Subject: Babcock & Wilcox Nuclear Energy, Inc. (B&W NE) Response to NRC Request For Additional Information

Reference: B&W NE Quality Assurance Program for the Design Certification of the B&W mPower™ Reactor Topical Report (TR) 08-00000320-000, Revision 0

Babcock & Wilcox Nuclear Energy, Inc. Response to  
Requests for Additional Information No. 5002 and 5039 Revision 0

B&W mPower Pre-Application Activities  
Docket No. PROJ 0776  
Topical Report 08-00000320-000

Figure 1.3 B&W NE Quality Assurance Organization

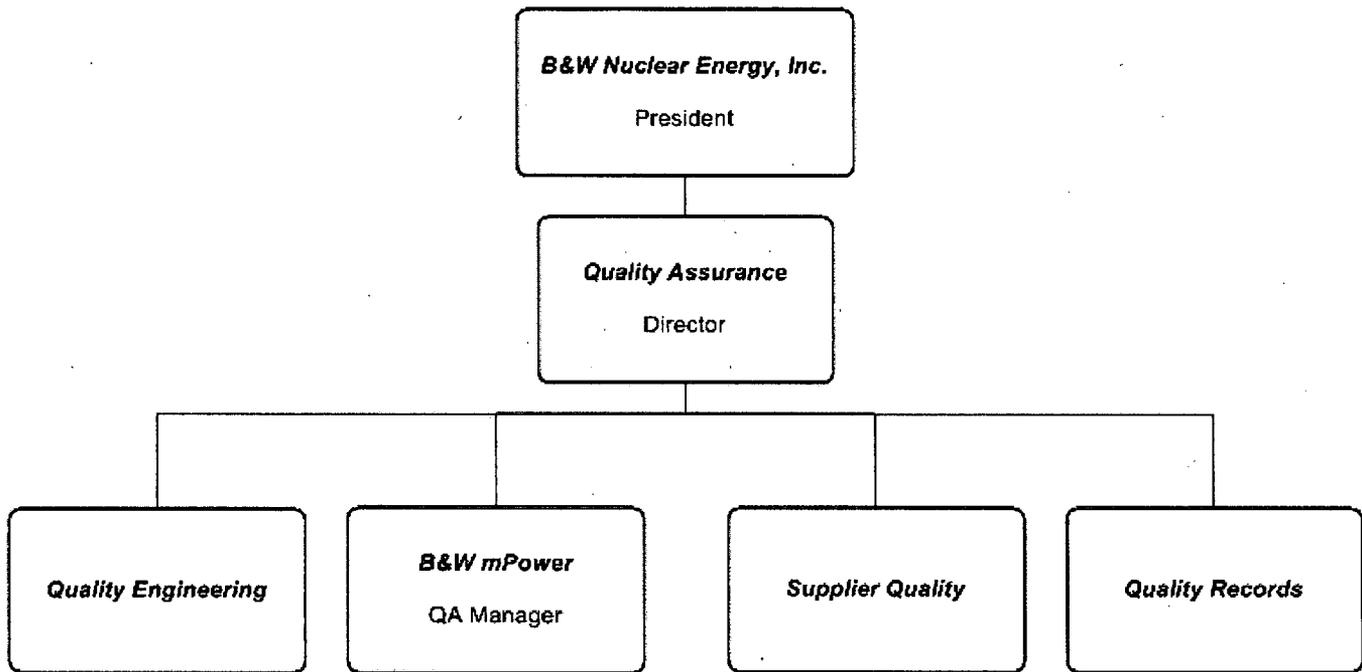
*Figure 1.3, B&W NE Quality Assurance Organization, is not defined in Section 1 of the B&W NE QAP. Please define the appropriate group functions depicted on Figure 1.3 and explain why NDE is included in the organization since fabrication is not within the scope of the QAP for design certification project as stated in the Scope/Applicability section of the Introduction.*

A more complete description of the Quality Assurance organization will be provided in section 1 of the B&W NE QAP. In addition, Figure 1.3 will be revised to delete the NDE function since it will not be within the scope of the QAP for the design certification project.

In addition, Figure 1.3 will be revised as shown below.
